SAVE THE ALEWIFE BROOK

April 28, 2022

Alewife CSO Control Plan Draft Scope

The Path to Zero Sewage Pollution

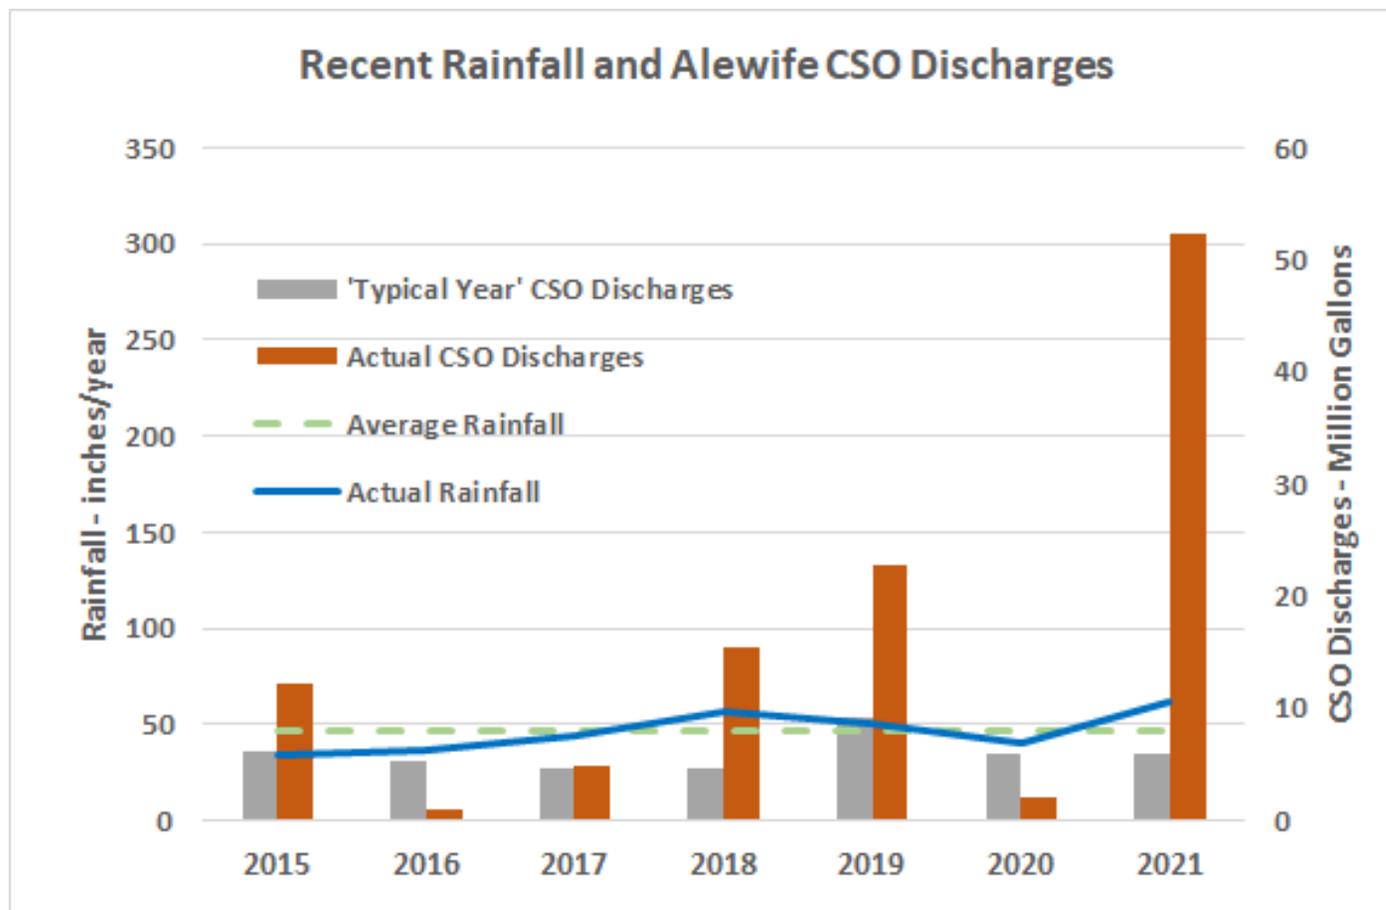
The table and figure below show recent CSO discharges and how much they have differed from the results of the Typical Year model.

Average annual rainfall is c. 46 inches (which varied by -27% to +33% during this seven-year period). The gray bars show the predicted CSO discharges based on the MWRA's "Typical Year" model, and average 6 million gallons per year. Actual CSO discharges, while varying considerably, average 15.8 million gallons per year, which is almost three times as much as predicted by the model. This clearly demonstrates that the CSO modeling based on the Typical Year does not represent current reality.

Environmental Justice Populations along the Alewife Brook. Alewife CSOs are marked in red.

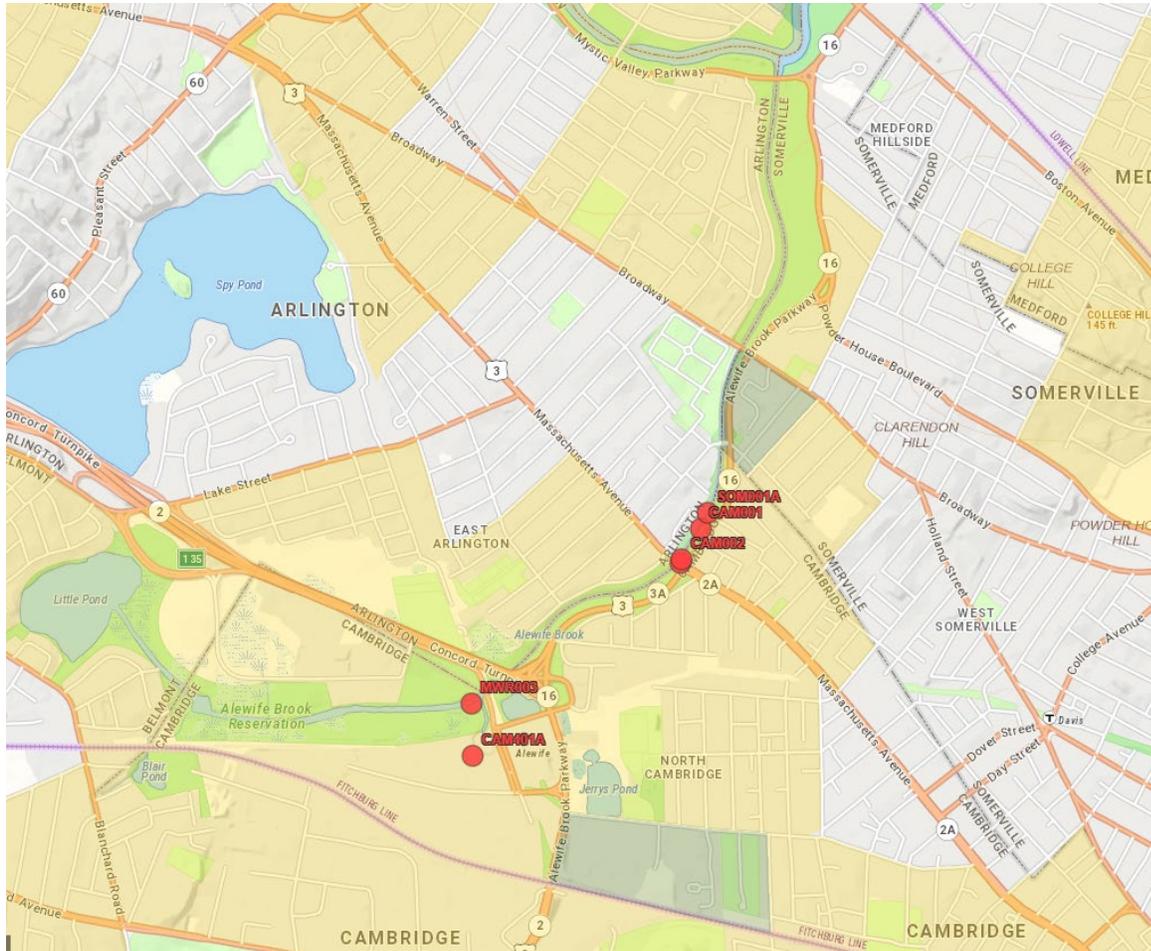
We must identify members of the Environmental Justice Populations in the watershed who are impacted by CSO sewage pollution. Impacts may include poor health outcomes from unavoidable contact with untreated sewage-contaminated flood waters, or it may include financial hardships associated with cleanup from sewage discharges and reduced real estate values.
